**SUBMISSION IN RESPONSE TO THE ENVIRONMENTAL ASSESSMENT OF THE
AGL DALTON POWER PROJECT**

Submission to the Proposed Development of a 1500MW Open Cycle Gas Turbine Power Station at Dalton

By the Community for Accurate Impact Assessment of the Dalton Power Station

Figure A-1

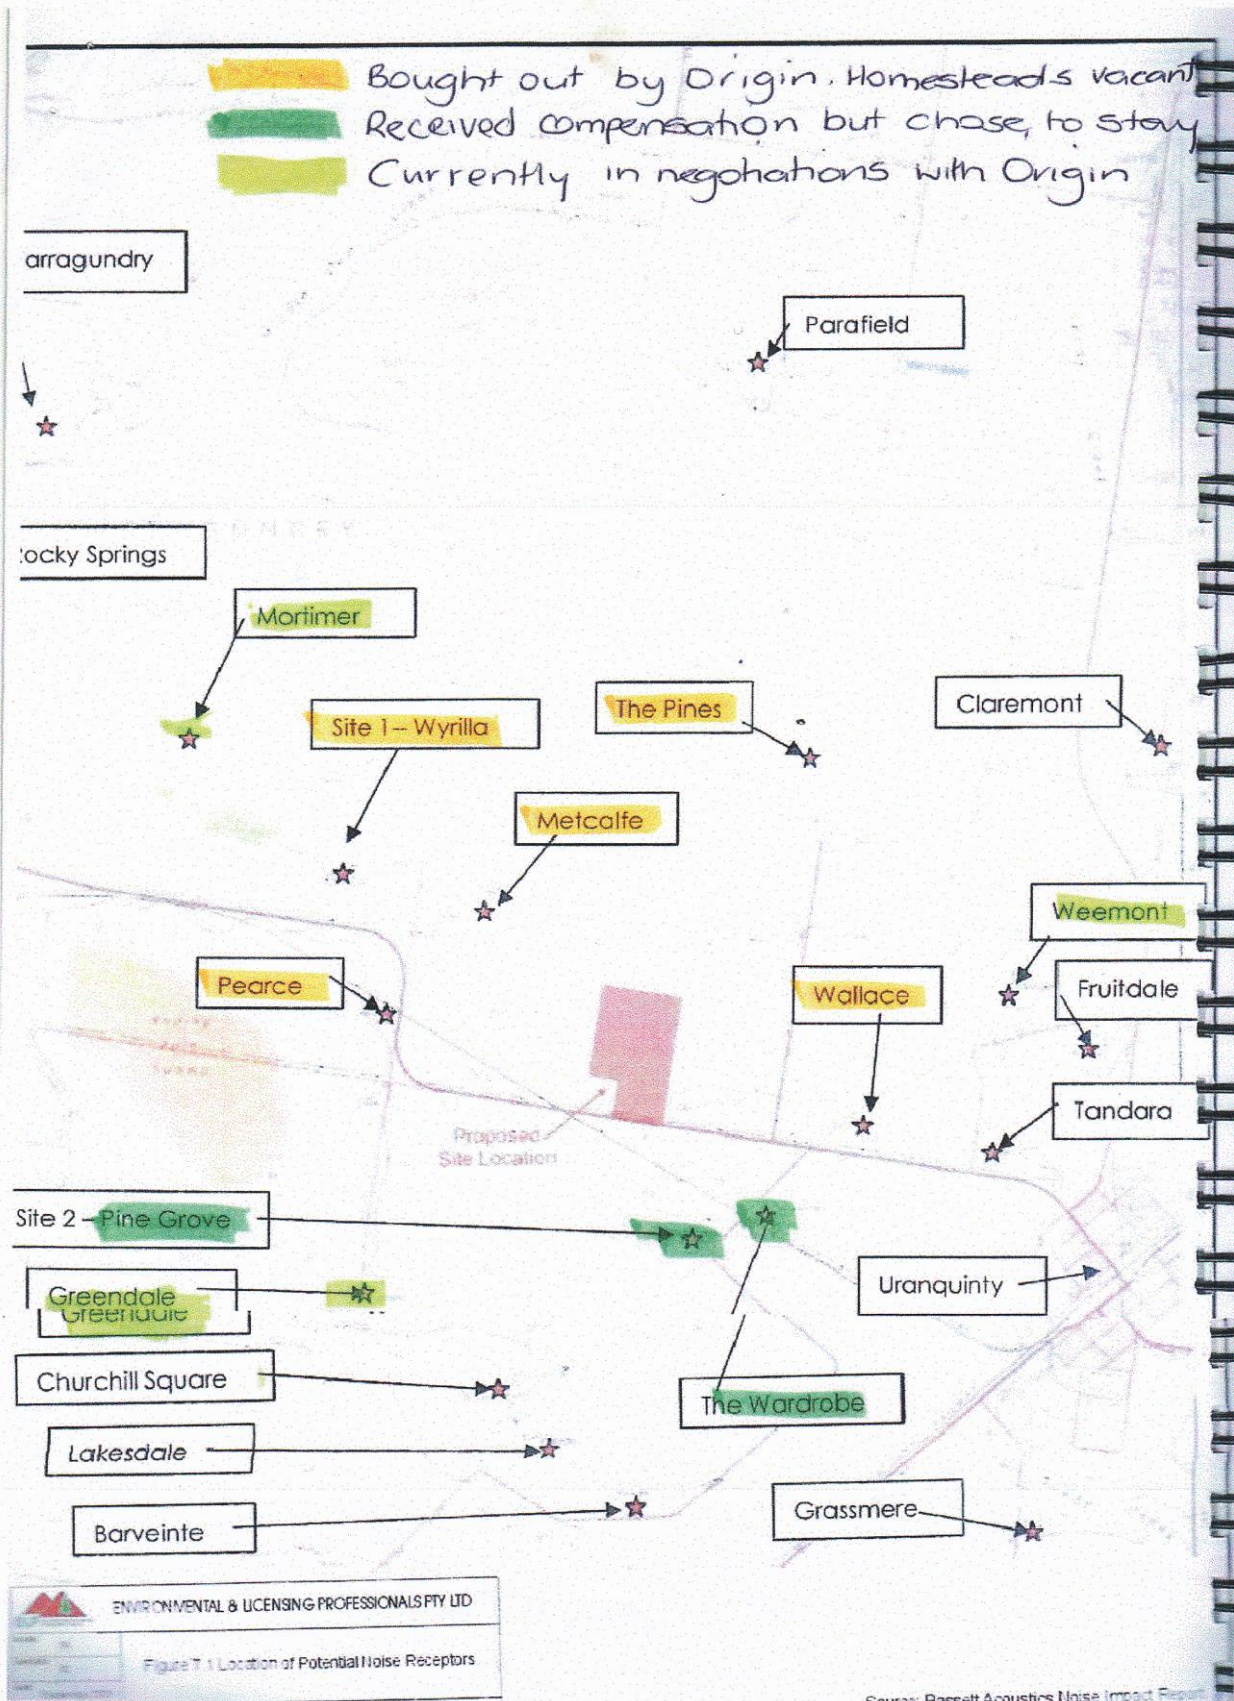
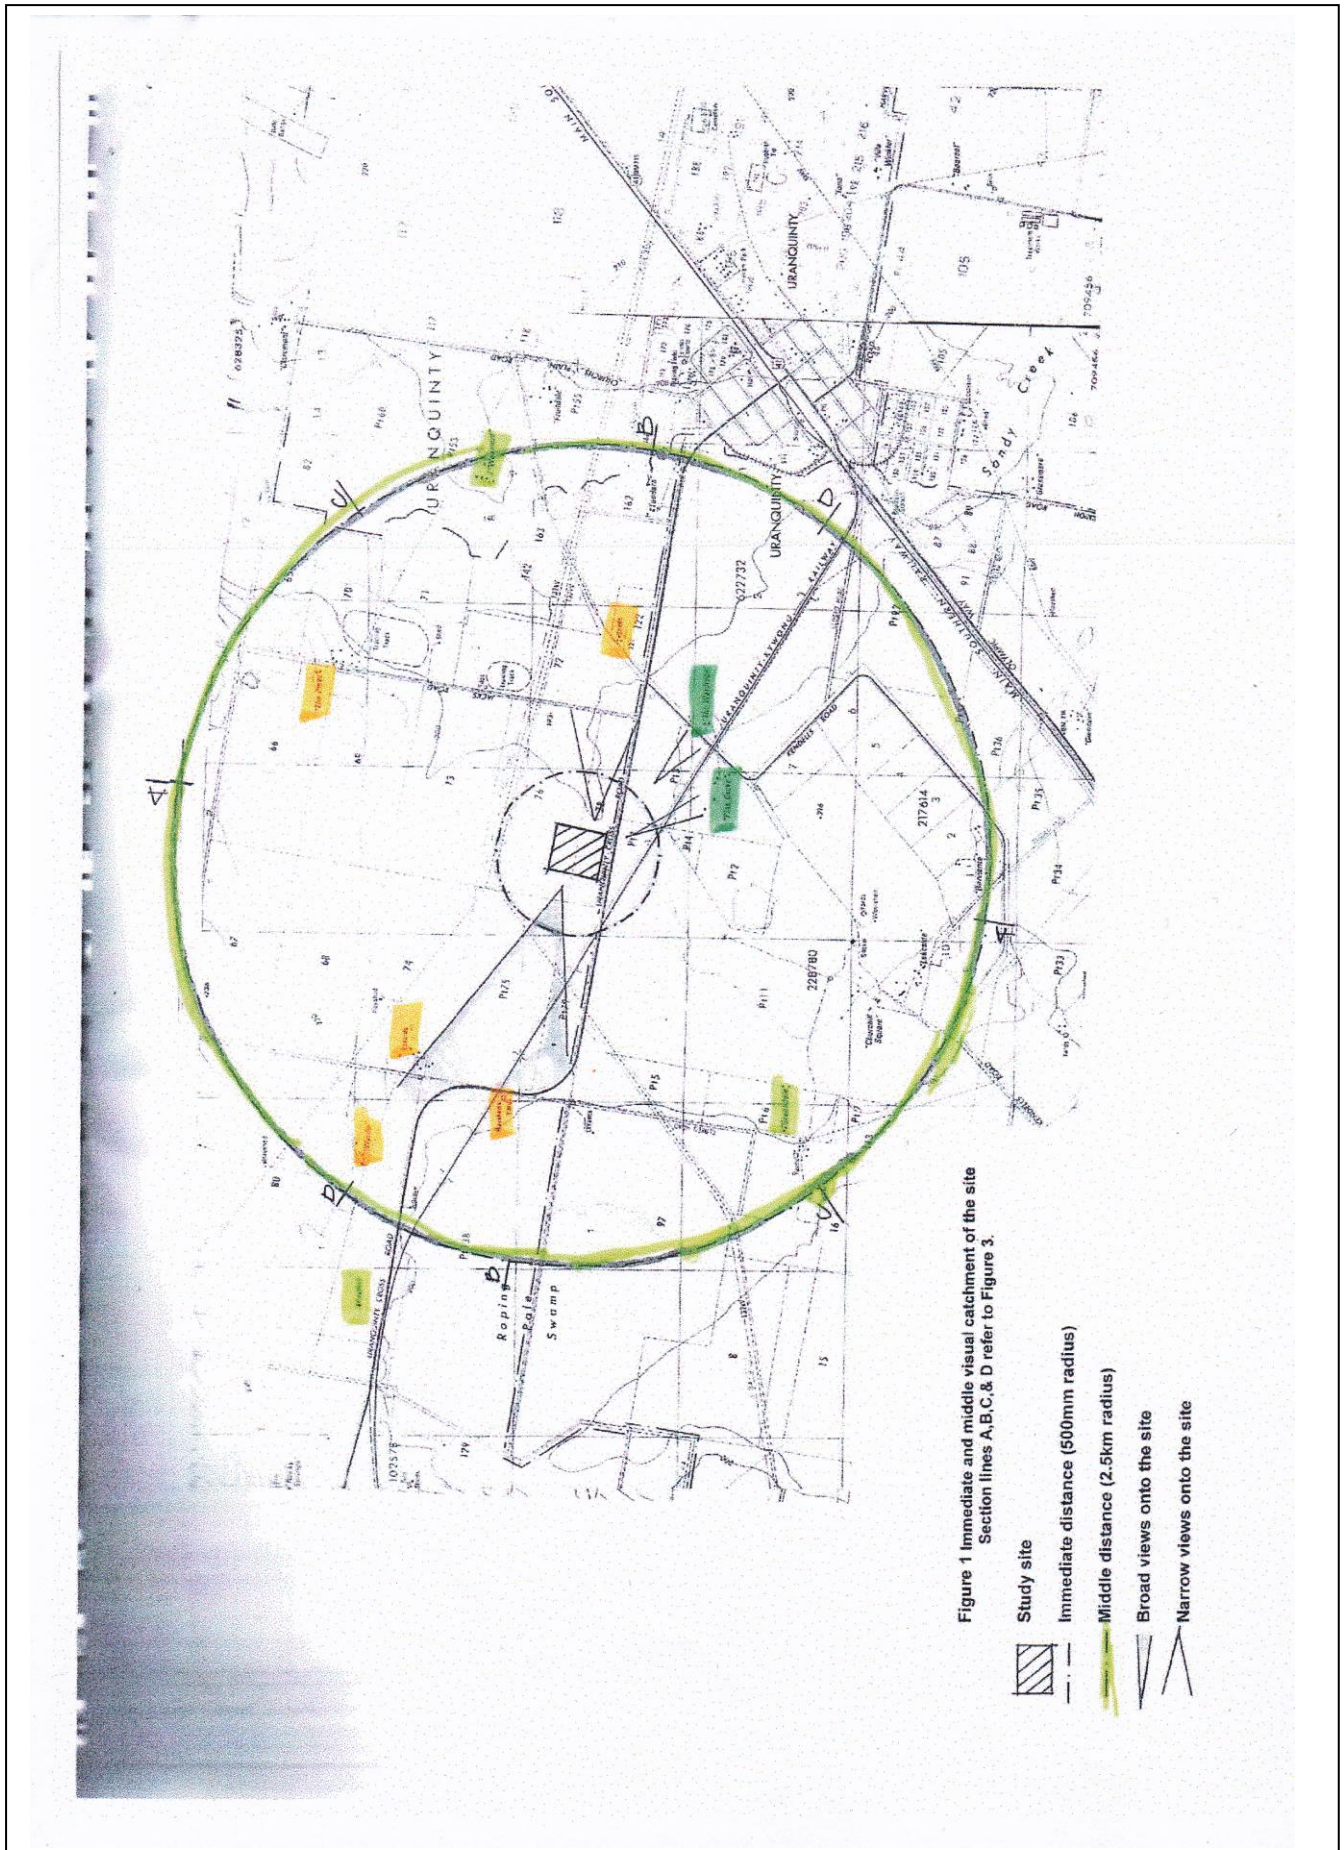
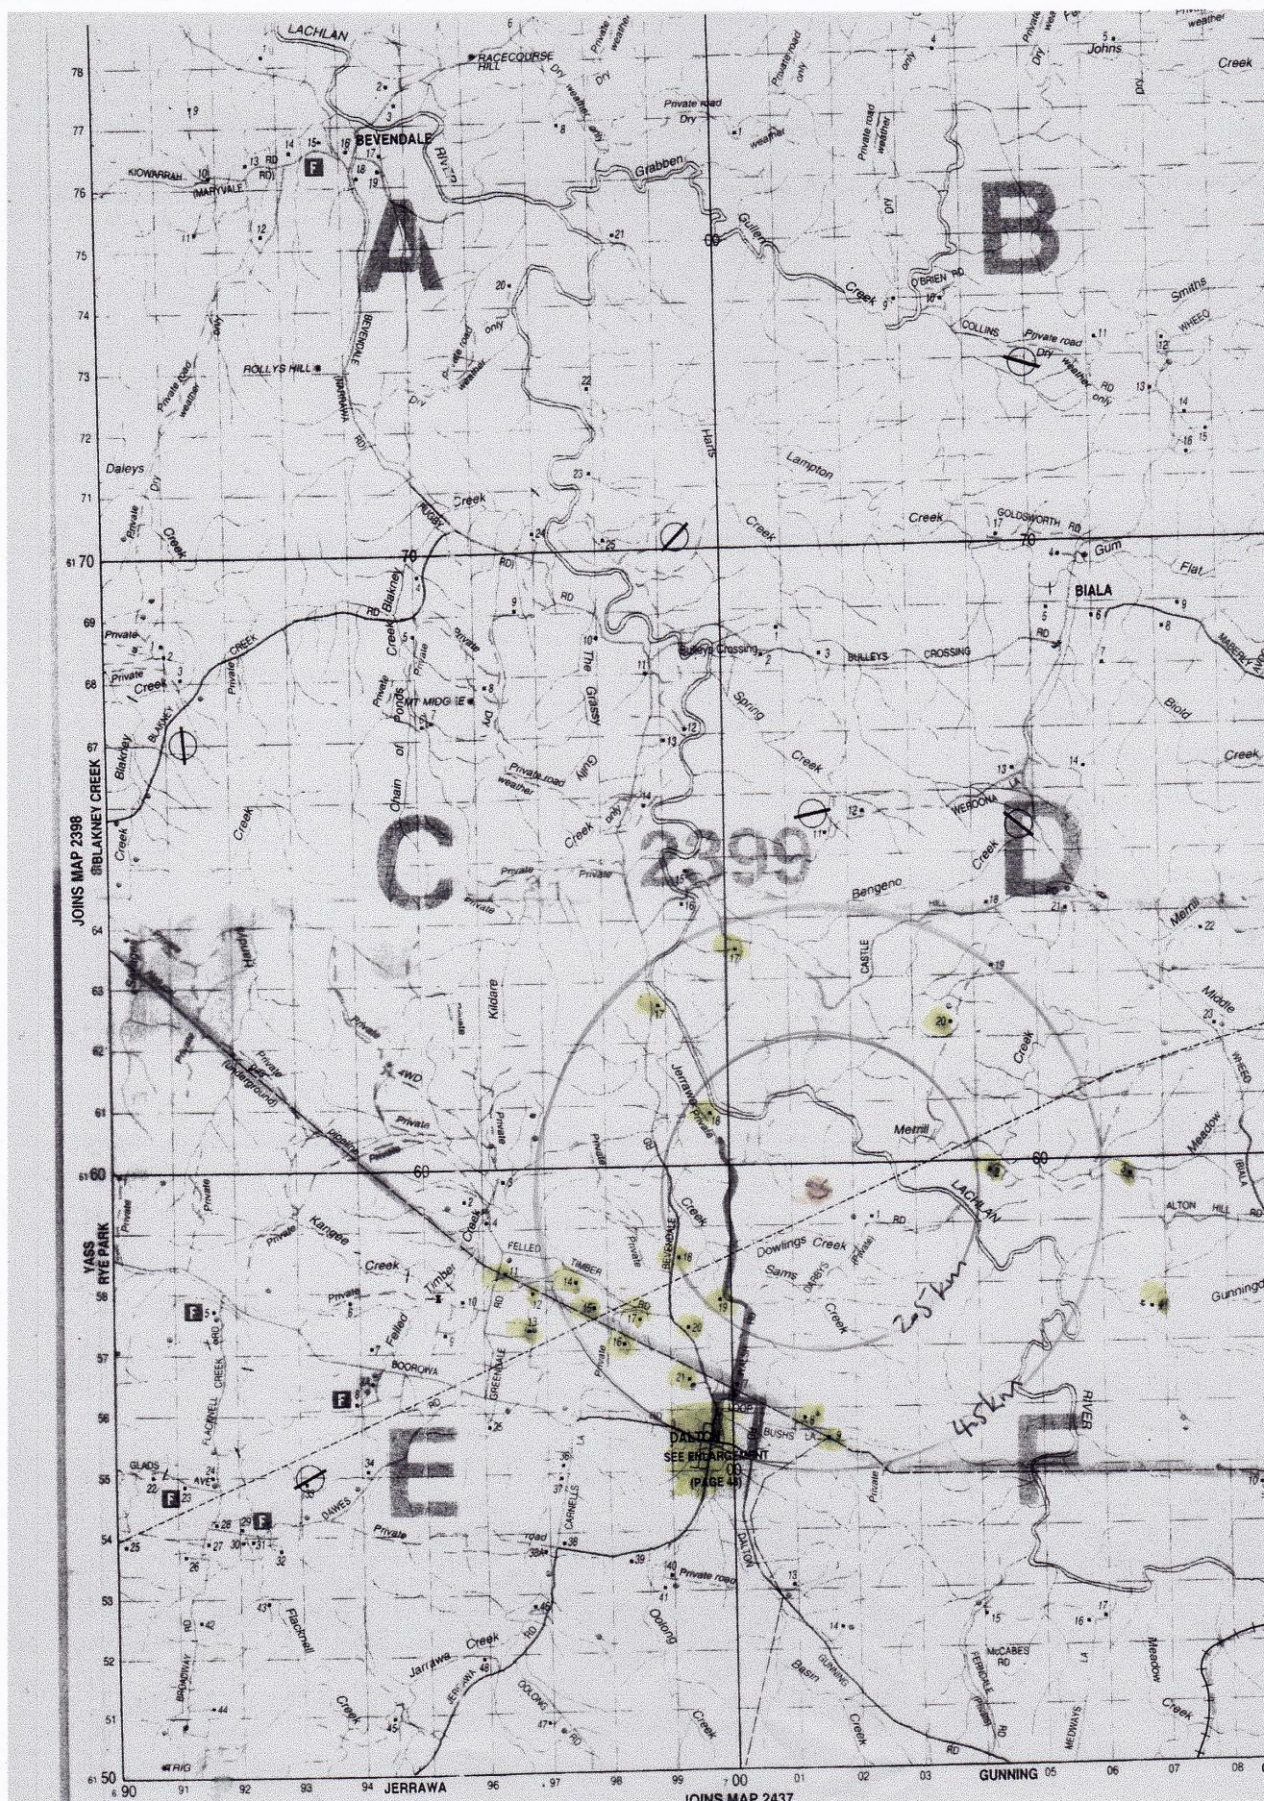
- 5 have been bought out by Origin and left the area (see Figure A-1 below)- Wyrilla & The Pines were 4th generation families;
- 2 have taken compensation payments for the next 5 years with the option to be bought out if the noise levels cannot be mitigated;
- 2 are currently in negotiations with Origin.

Figure A-2: Radius of 2.5km from the Uranquinty power station and the location of dwellings

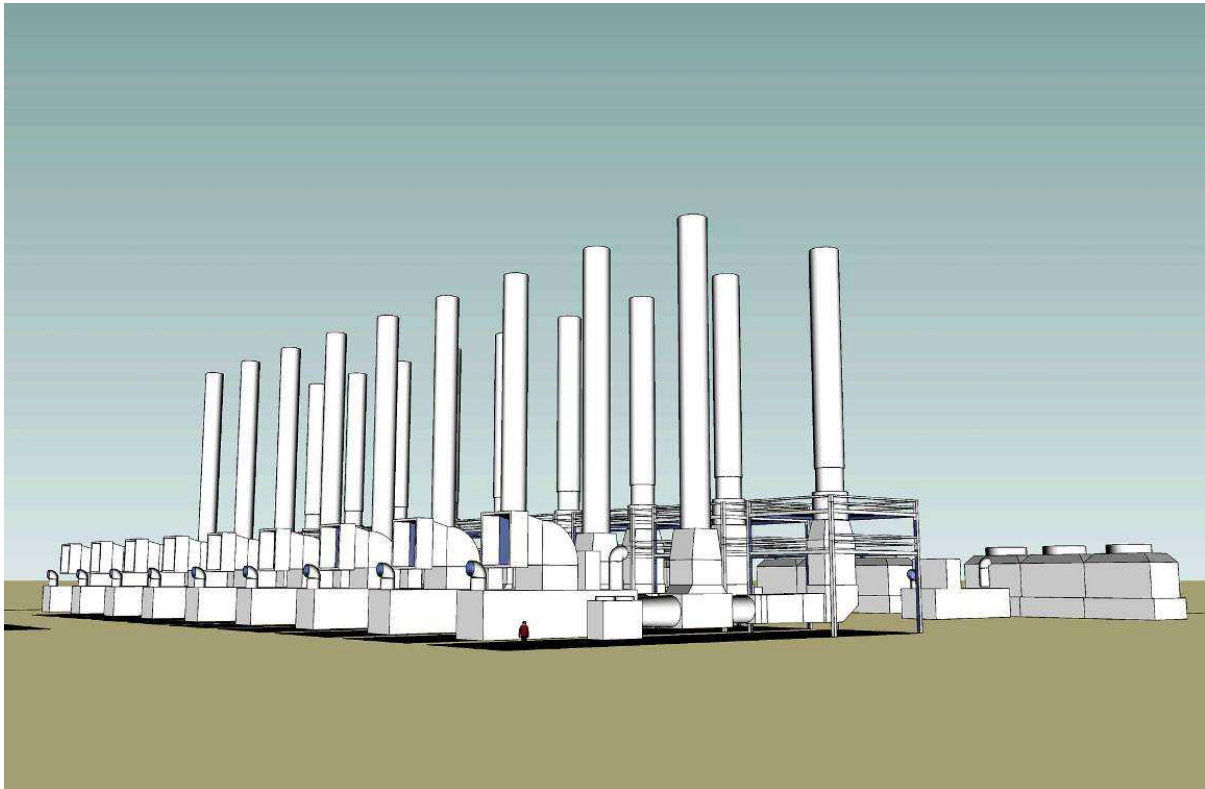
5.6 The Dalton power station is a greater distance from dwellings than the Uranquinty power station but it is more than twice as big and not all residents are protected by distance. AGL argue that they have done a better job than the Uranquinty gas fired power station at buying surrounding properties to ensure a better buffer between impacted neighbours. This is not entirely the case. There are three dwellings less than 2.5km from the Dalton site and many a little further out, including the town of Dalton 3.7km away. As residents 2.5km away have been forced from their homes in the case of the smaller Uranquinty power station, it would seem the proposed AGL power station, being more than twice as large, will cause significant adverse noise impacts. A map showing the location of residences near the Dalton power station site is shown in Appendix B of this submission. A map showing the location of residences near the Uranquinty power station site, where families have left their homes, are in negotiations to leave, or are being paid compensation for noise, is shown in Appendix A of this submission.

In Figure A-2 the circle with a 2.5km radius shows the location of residents relative to the Uranquinty power station.
